NG-18-0015 10 CFR 50.90

Duane Arnold Energy Center Docket No. 50-331

Subject: Response to Second Request for Additional Information Regarding License Amendment Request (TSCR-168), Application to Revise Technical Specifications to Adopt TSTF-542, "Reactor Pressure Vessel Water Inventory Control"

Proposed Technical Specification Change (Mark-Up)

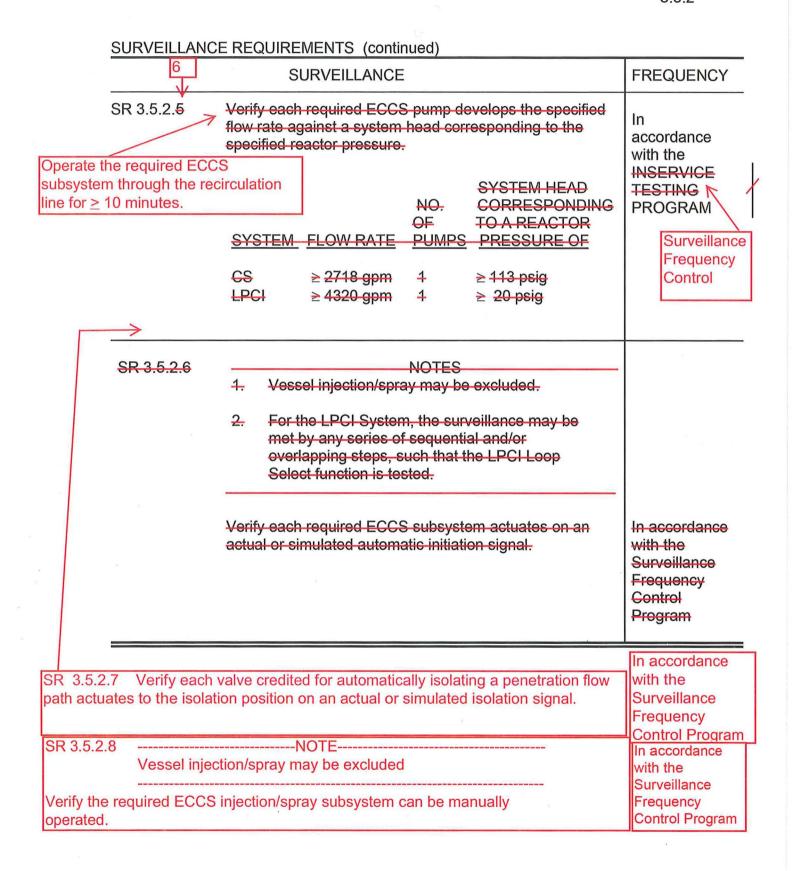
The markup pages provided on the RAI response letter of TS related to DRAIN TIME definition replaced "TAF" with "T.S. 2.1.1.3 Safety Limit;" however, as stated in RAI-1, the changes to TAF has global effects on the LAR including, but not limited to; TS LCO 3.5.2. For example, there are two places in TS LOC 3.5.2 that "TAF" is noted.

Justify why these sections, including TS LCO 3.5.2, do not need to be modified, or make appropriate changes to all sections.

NextEra revised the proposed changes in TS 3.5.2 to replace "TAF" with "TS 2.1.1.3 Safety Limit." Similarly, references to "TAF" in the proposed changes to the TS Bases are replaced with "TS 2.1.1.3 Safety Limit." Revised markups of the TS pages, retyped TS pages, and changes to the TS Bases that incorporate this change are provided in the attachments to this enclosure.

INSERT B-5 (SR 3.5.2.6-8)

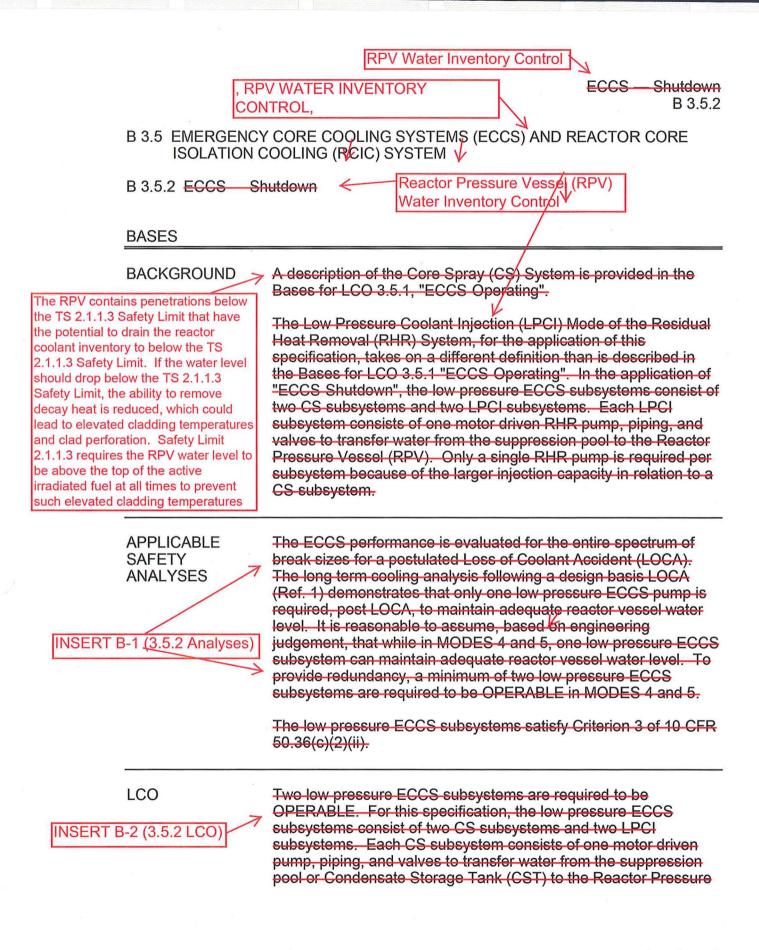
Although TSTF-542 SR 3.5.2.8 and proposed DAEC SR 3.5.2.6 both test ECCS spray/injection subsystem function, they are not equivalent tests. The intent of TSTF-542 SR 3.5.2.8 is to verify that the required ECCS subsystem actuates on a manual initiation signal, including pump start and

realignment of all valves to their required positions. Where a manual initiation push button and logic are not available, an alternative is required to meet the intent of this testing (i.e., to verify that the required ECCS spray/injection subsystem can be manually operated.) The proposed DAEC SR 3.5.2.6 requires testing the flow of water through the recirculation line, but does not require testing for operability of the injection valves.

Please provide the following: 1) Describe how verification of operability is obtained for the ECCS spray/injection subsystem valves, which are normally closed during Modes 4 and 5; and 2) identify the SR in which the requirements are contained.

NextEra proposes to add new SR 3.5.2.8 to DAEC TS 3.5.2, which will accomplish the intent of SR 3.5.2.8 in TSTF-542. The SR will verify the required ECCS injection/spray subsystem, including the associated pump and valves, can be manually operated. The surveillance frequency will be in accordance with the Surveillance Frequency Control Program with an initial frequency of 24 months (once per refueling cycle). The attachments to this enclosure provide revised markups of the TS pages, retyped TS pages, and changes to the TS Bases that include the addition of new SR 3.5.2.8.

The required ECCS subsystem must be capable of being manually operated. This Surveillance verifies that the required ECCS injection/spray subsystem, including the associated pump and valves, can be manually operated.
